ADDENDUM #1
INVITATION FOR BID #24-76

MASON RICE SCHOOL ROOF REPLACEMENT

Addendum to the Bidding Documents
Mason – Rice Elementary School
Roof Replacement Project

Addendum No. 1
June 3, 2024

1 EXISTING ROOF SELECTIVE DEMOLITION PLAN
SCALE: 3/32" = 1'-0"

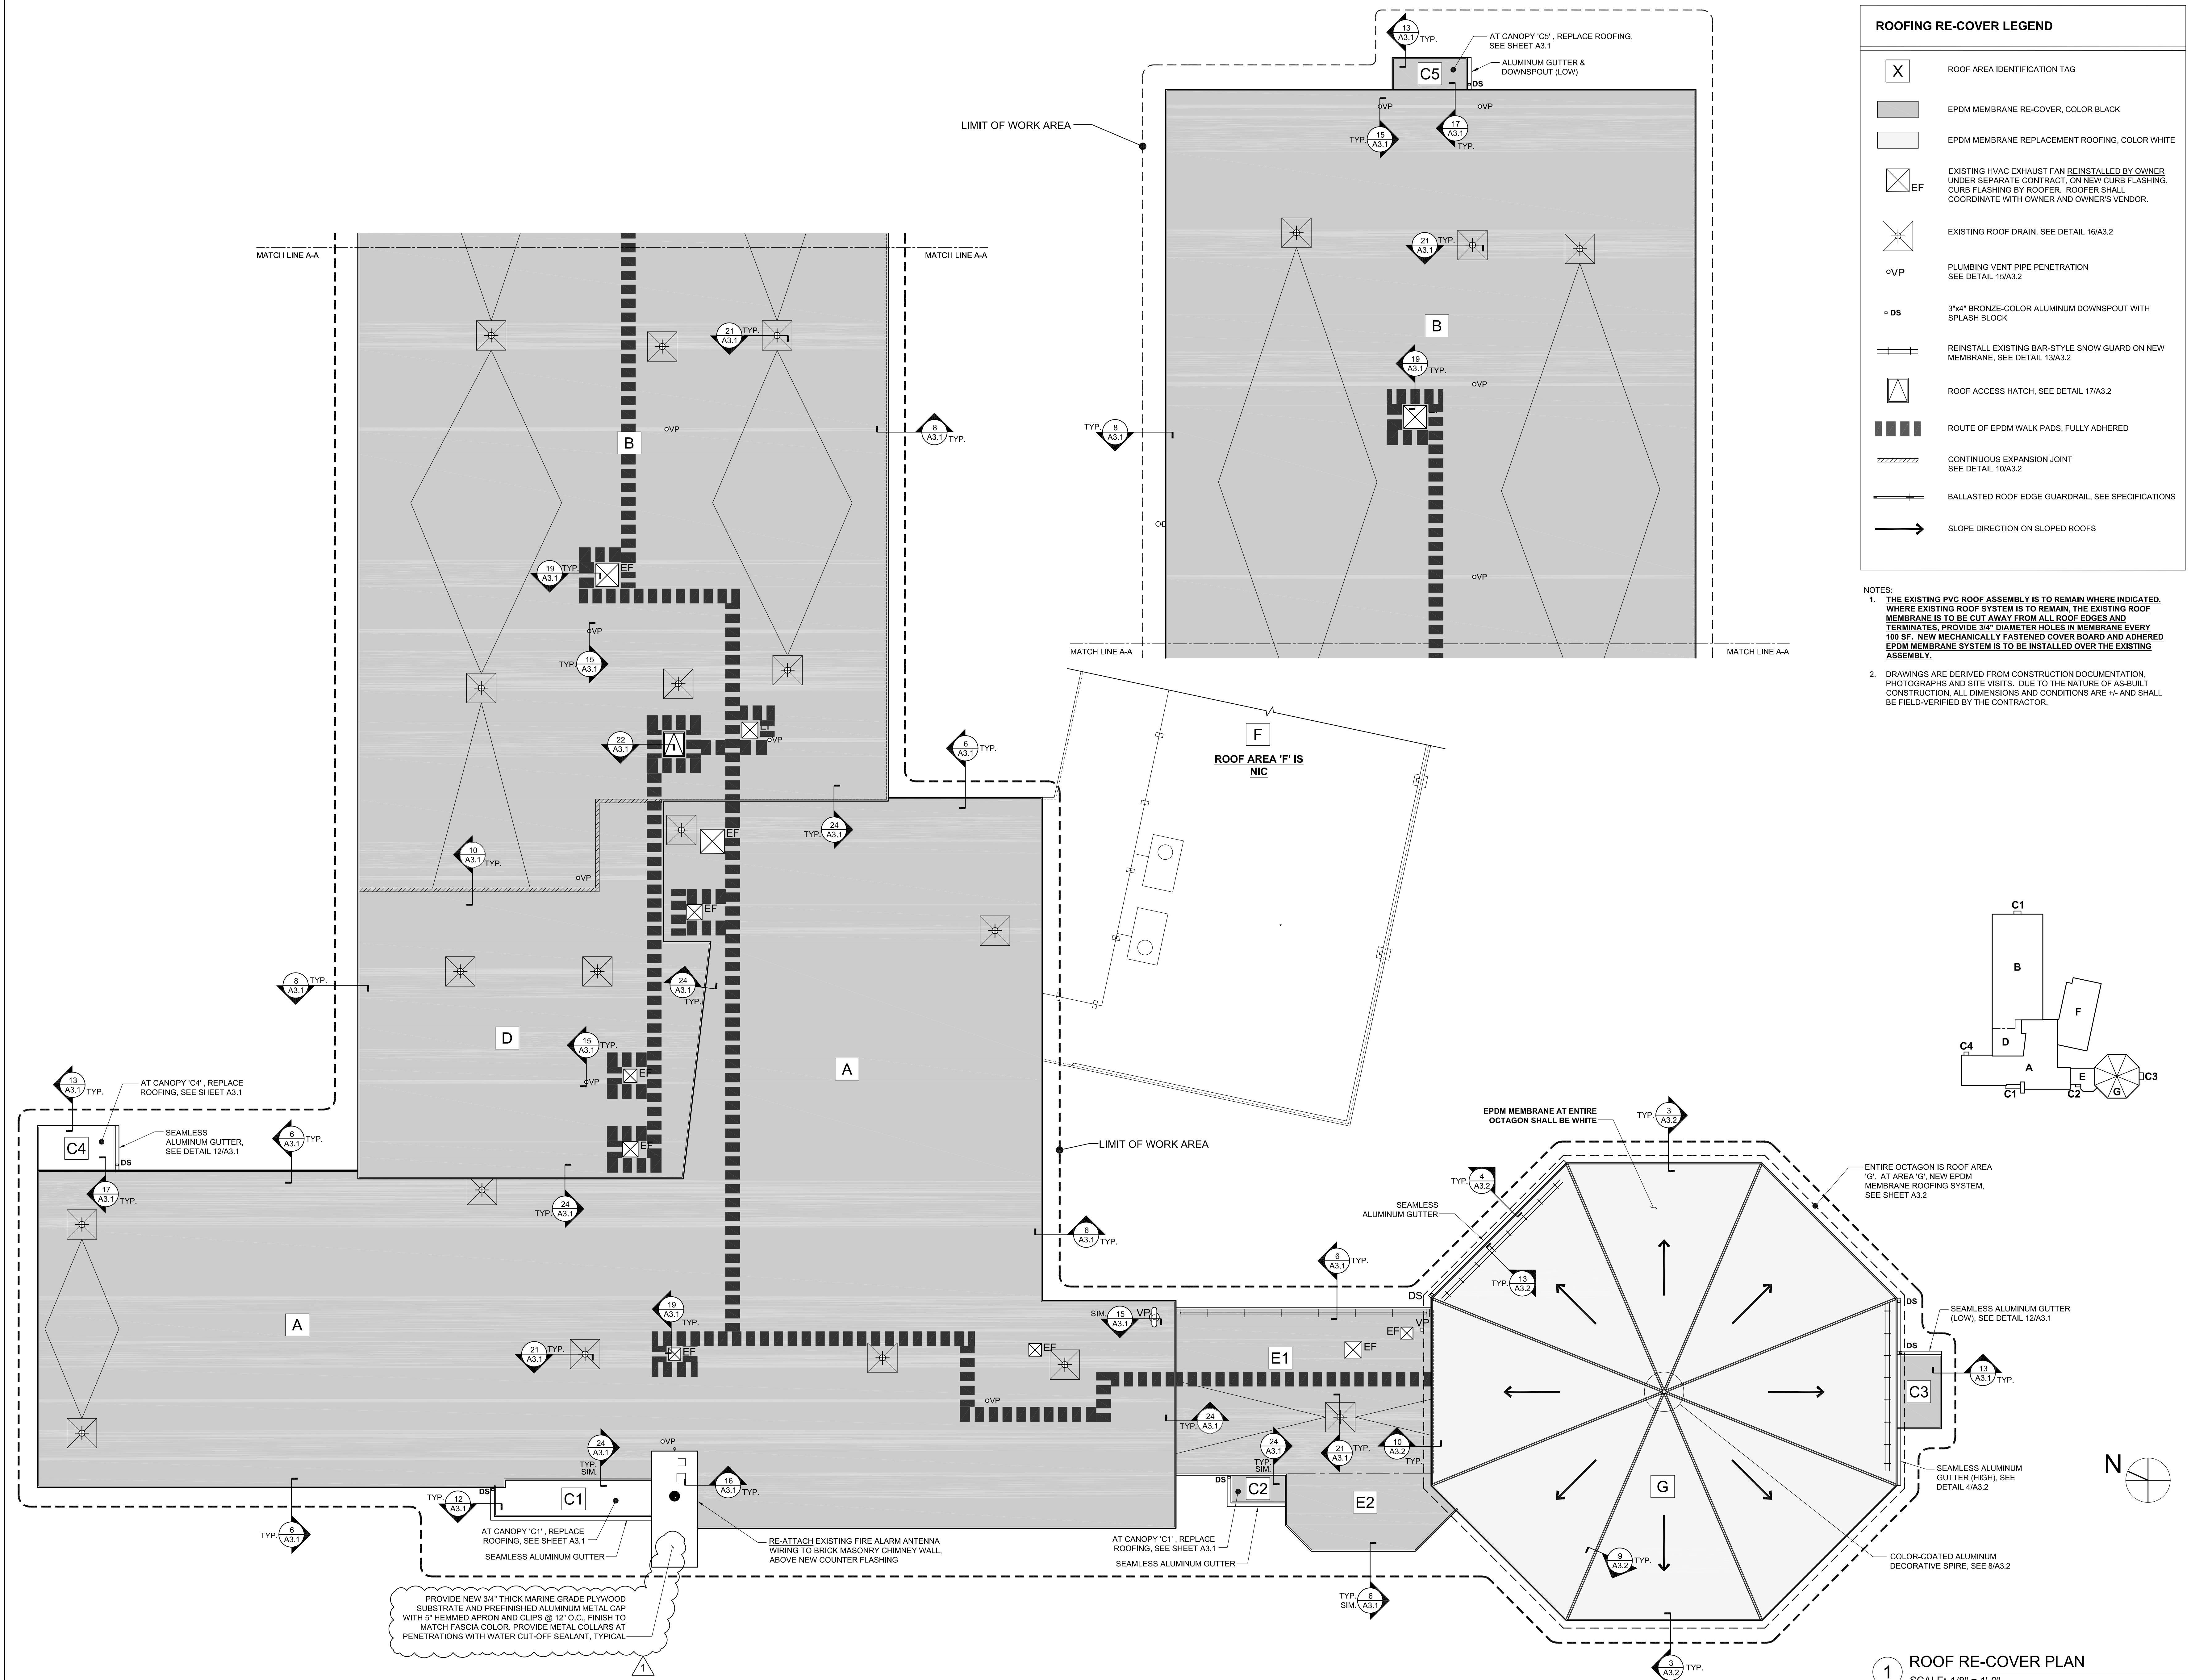
Item No. A-1.02 - Drawing “**A1.1 EXISTING / DEMOLITION PLAN**”, **REPLACE** with Drawing “**A1.1 EXISTING / DEMOLITION PLAN** dated 6/3/2024” in its entirety.

No.	Date	Description
1	6/3/2024	CHIMNEY CAP
